RE: DA2018/1820 – 74 Bower St Manly

We are writing on behalf of the owners of 76 Bower St, Manly in regards to a Development Application lodged with Northern Beaches Council for 74 Bower St, Manly

View from Bedroom 3 balcony (standing position) – 76 Bower St

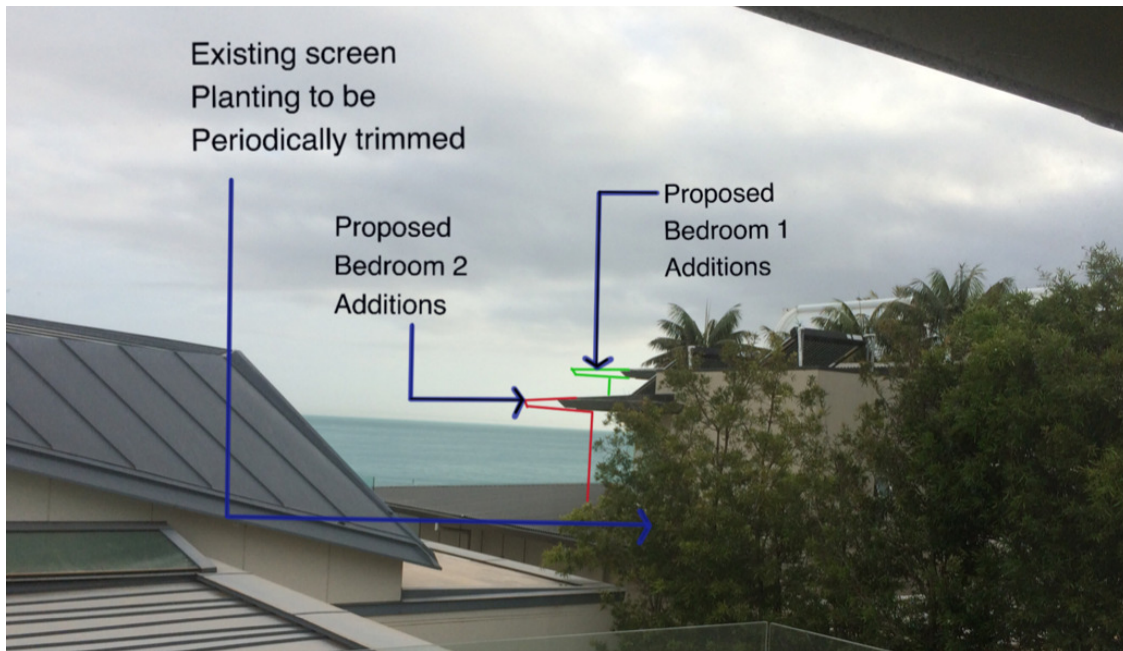
The extension of bedrooms 1 and 2 to the northern elevation results in view loss for our clients from the central balconies and bedrooms on the top floor.

Please find below two photos indicating the impact on views from the two areas of concern.

The views affected to our clients are of water views. As noted above, water views are valued more highly than land views.

The views affected to our clients are view currently enjoyed diagonally across the side boundary, from the centre of the site to the rear. The views are from standing positions which should be protected.

Although the views affected are from bedrooms and their associated balconies, we would like to note that these bedrooms have been designed in great detail, not to mention the considerable cost to obtain water views. They were orientated in such a way that their views would not be affected by non-compliant additions to neighbouring buildings.

As mentioned above, the views affected to our clients are the result of additions that will breach the LEP planning controls for FSR. We would like to note that the existing dwelling on 74 Bower st already breaches the FSR controls by 0.2:1 and the proposed additions will breach the FSR by up to 0.5:1.

The proposed additions are unreasonable in that they will encroach on existing water views by non-compliant additions.

To summarise, we object to the proposed additions and request that the proposal is amended to reduce impacts on the existing amenity enjoyed by our clients.
